ADDENDUM #04

Project Name: Central County Fire & Rescue House #06

Project Number: 24057

Date: July 20, 2026

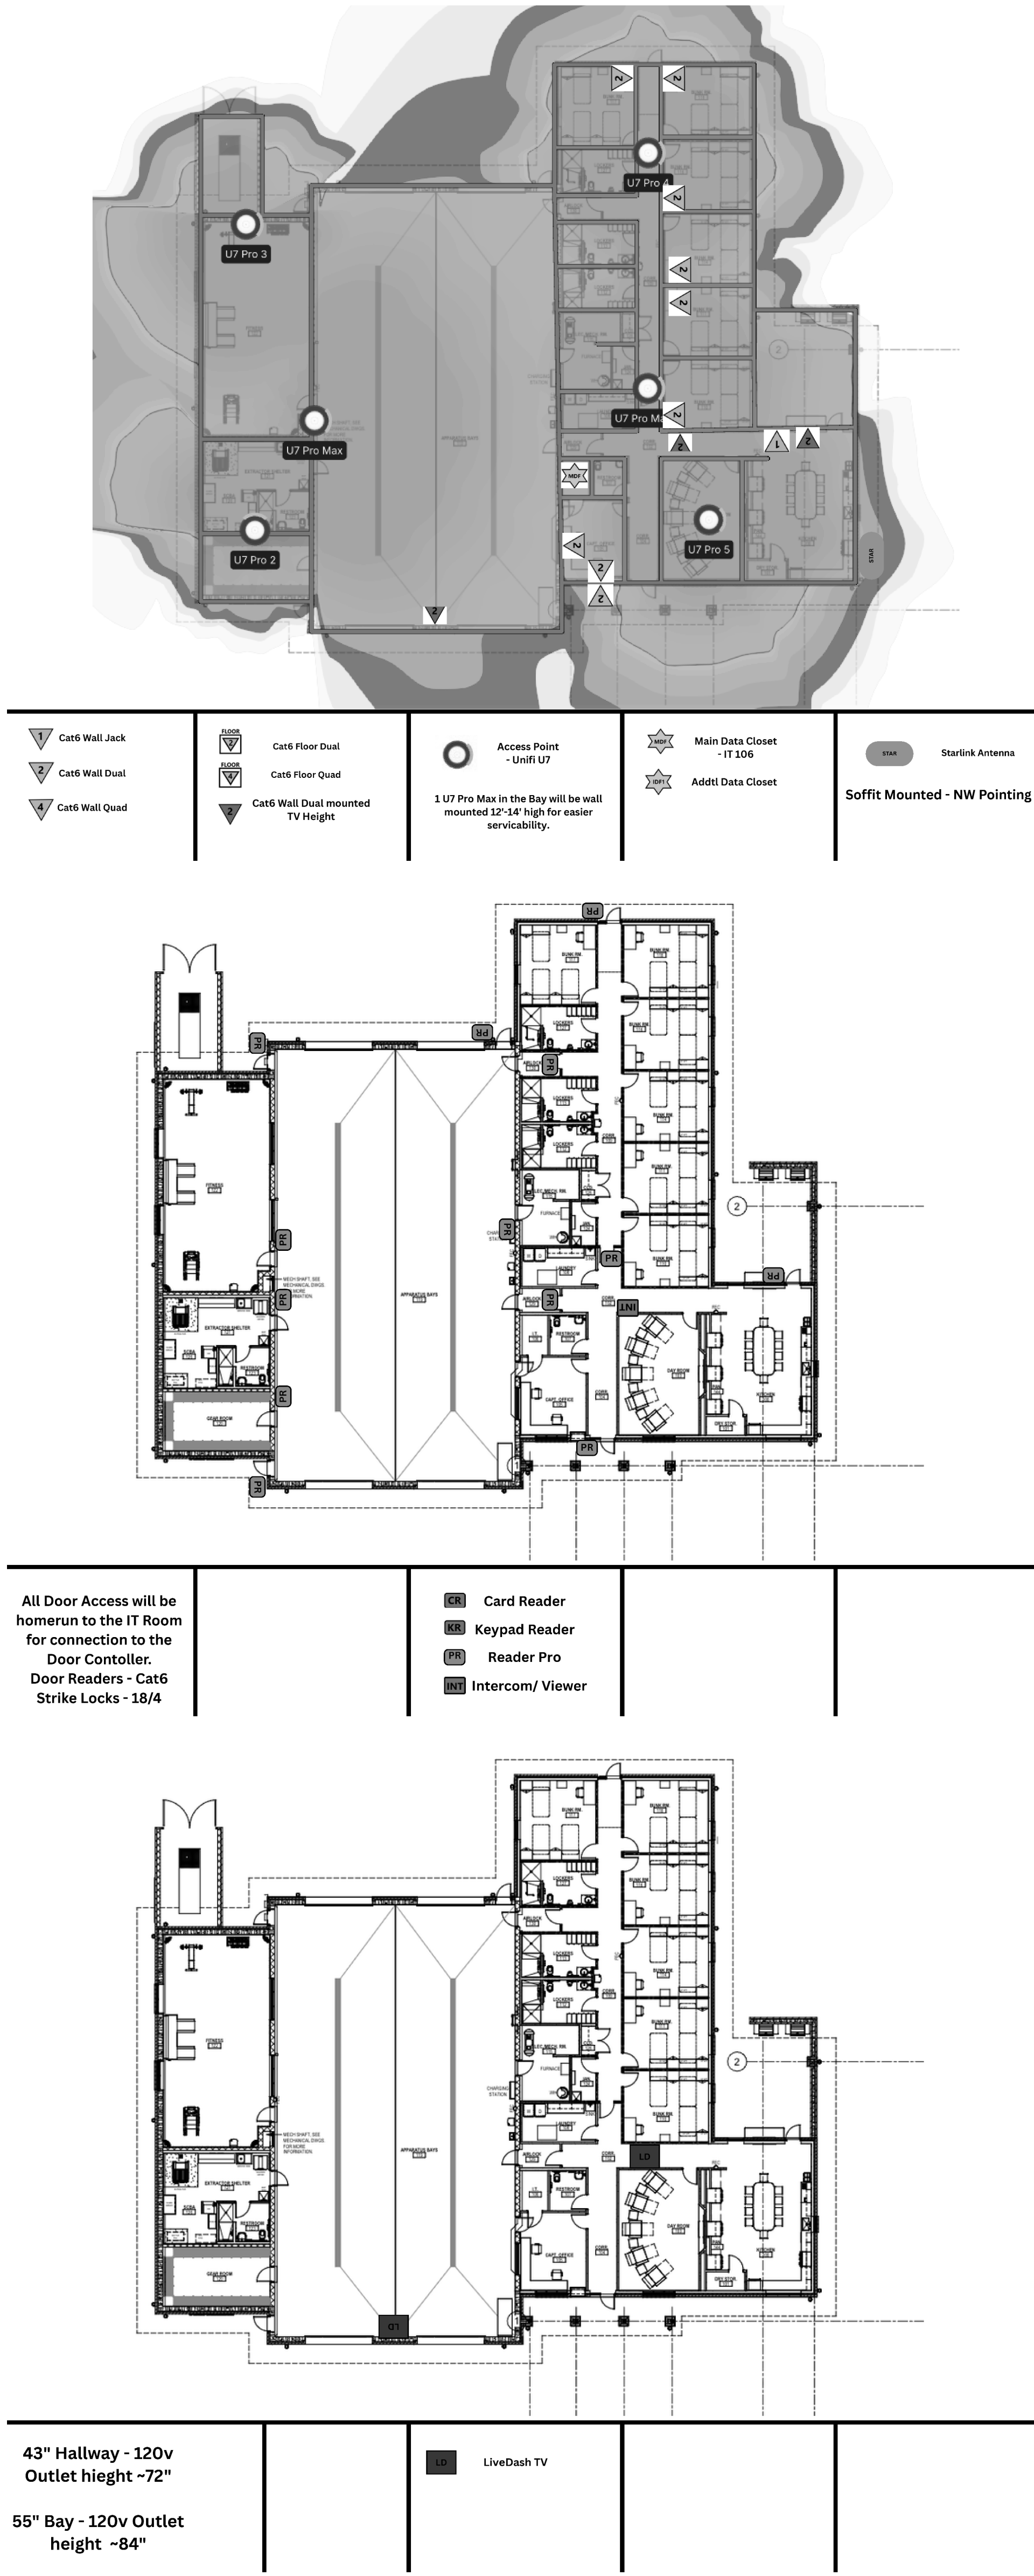
1. Sheet E001 - ELECTRICAL SYMBOLS & ABBREVIATIONS
 - a. Added the following table to identify Station Monitoring System

Station Monitoring System - Refer to Sheet E403
